REMARKS

Application No. 09/778,371

AMENDED CLAIMS MARKED UP TO SHOW CHANGES
SUBMITTED IN ACCORDANCE WITH 37 CFR 1.121(c)(1)(ii)
IN RESPONSE TO OFFICE ACTION OF JULY 30, 2002

Fig. 1

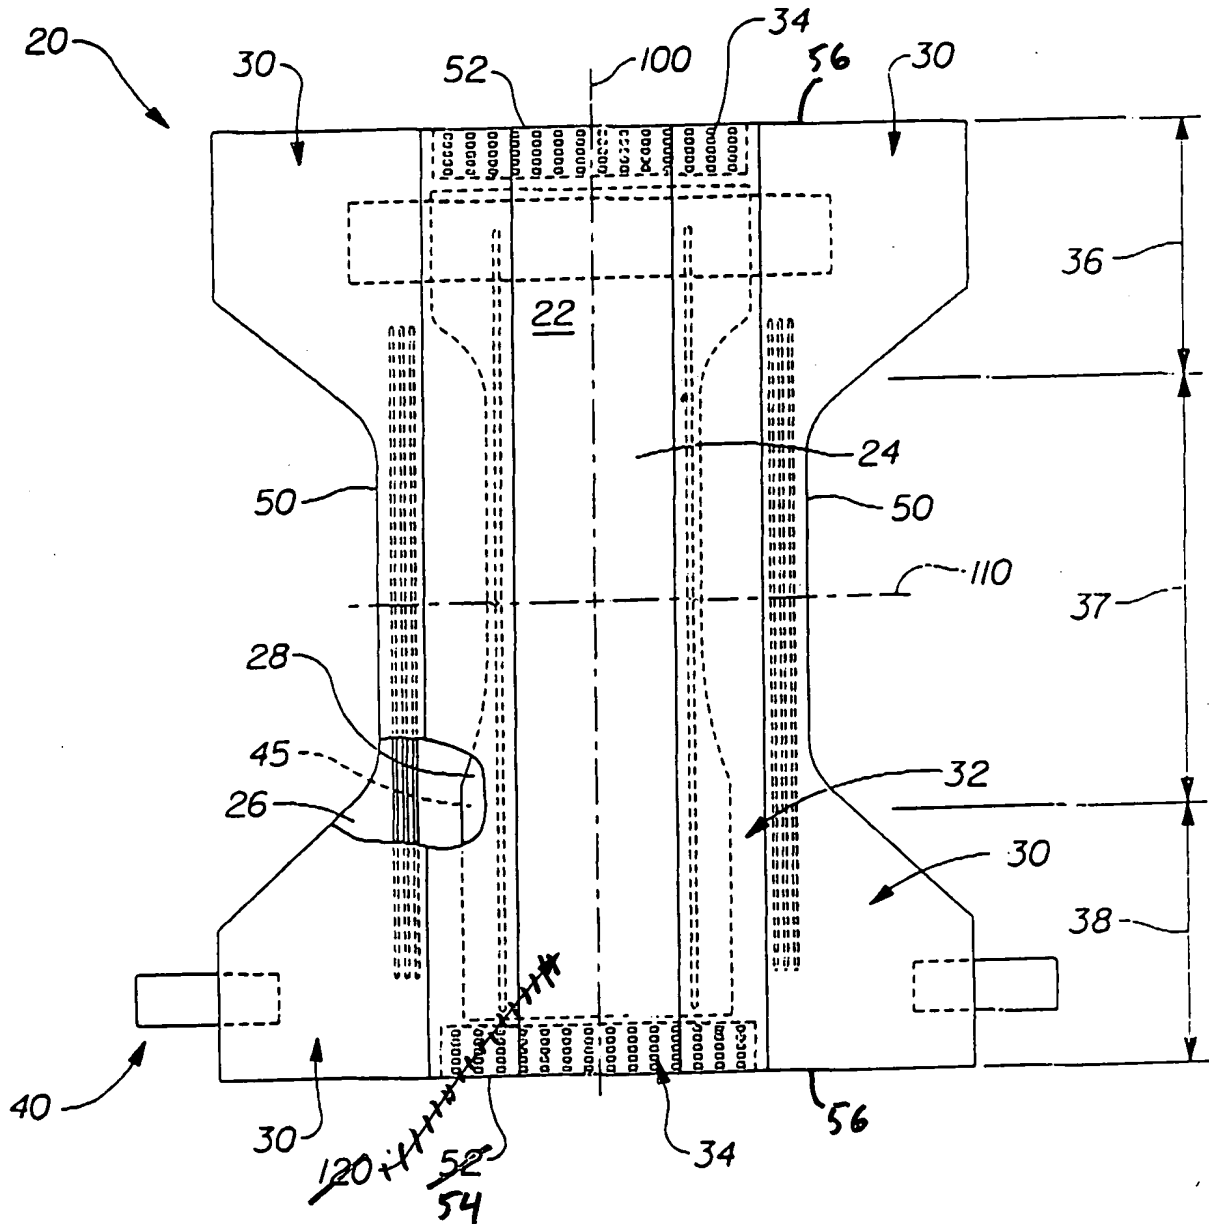
- Figure 1 has been amended to replace reference numeral 52 that is located in the back waist region 38 with reference numeral 54, defined as the back end edge at page 7, line 9.

- Figures 1 and 2 have also been amended to include reference number 56 to define both waist edges as described on page 7, line 8. The paragraph bridging pages 4 and 5 has been amended for consistency.

- Figure 1 has been amended to delete reference numeral 120 for consistency with the Specification.
- With respect to reference numeral 38, the Applicants respectfully direct the Examiner to page 5, line 3 which defines the numeral. Figure 4 has also been amended to remove reference numeral 38 and the element delineated thereby to be consistent with the description in the Specification.
